WATER QUALITY MEMORANDUM

Utah Coal Regulatory Program

RE: Fourth Quarter of 2012 Water Monitoring, Savage Services Corporation, Savage Coal Terminal, C/007/0022, Task #4226

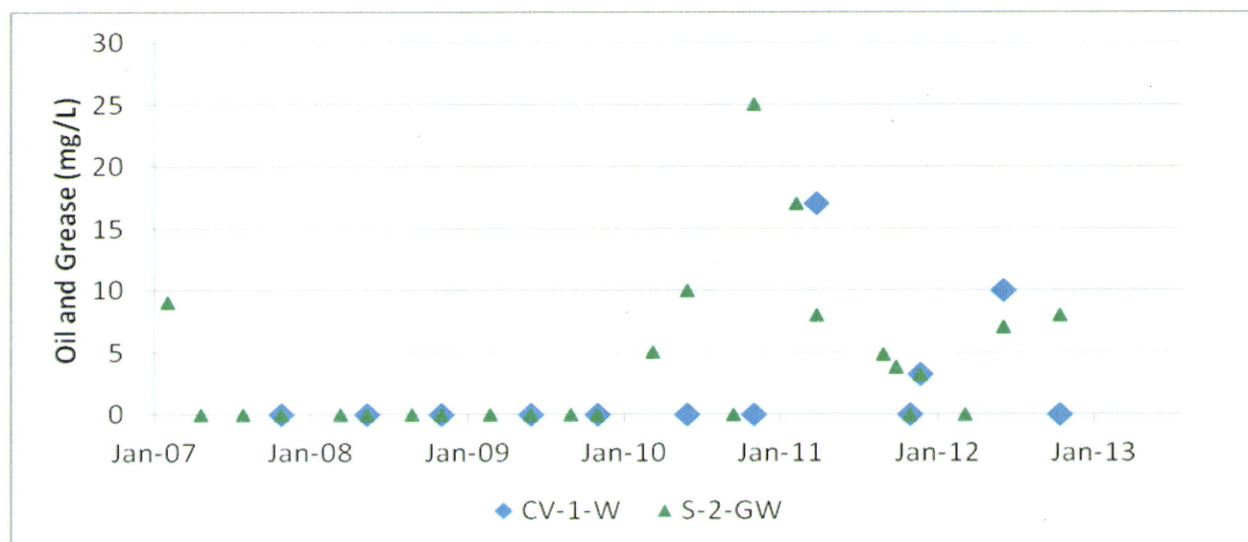
Monitoring well CV-1-W, S-1-GW, S-2-GW, and S-3-GW were monitored during the fourth quarter on October 30, 2012. Well S-2-GW detected oil and grease at a concentration of 8

mg/L in the sample collected on October 30, 2012. Included is a graph of the oil and grease detections at wells S-2-GW and CV-1-W since 2007.
